6 August 2015

Subject: Vancouver Energy
EFSEC Application No. 2013-01, Docket No. EF131590
Response to EFSEC Draft EIS Data Request Regarding Seismic Design of Area
300 Secondary Containment Berm

Figure 2.3-10. Containment Berm Cross Section

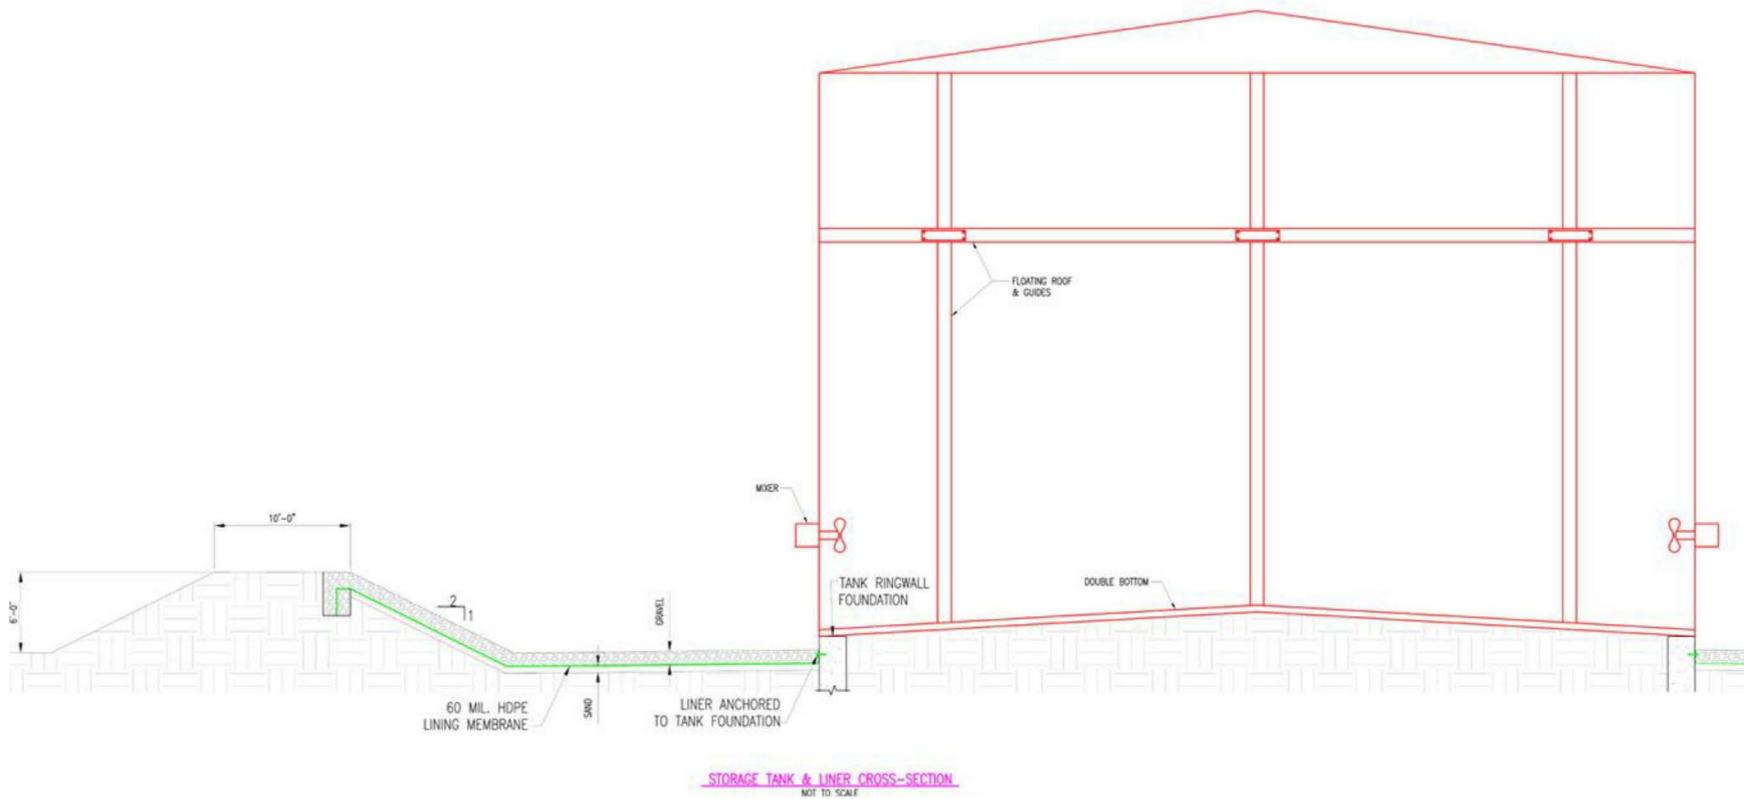
1. What is the slope of the proposed 6-ft high berm?

The inside slope of the berm is anticipated to be approximately 2:1. See Figure 2.3-10 of the Application for Site Certification Supplement (ASC Supplement) (Jan 2014) and Figure 4 (page A-12) of the Operations Spill Prevention Control and Countermeasures Plan (June 2015), attached to this response letter for your convenience.
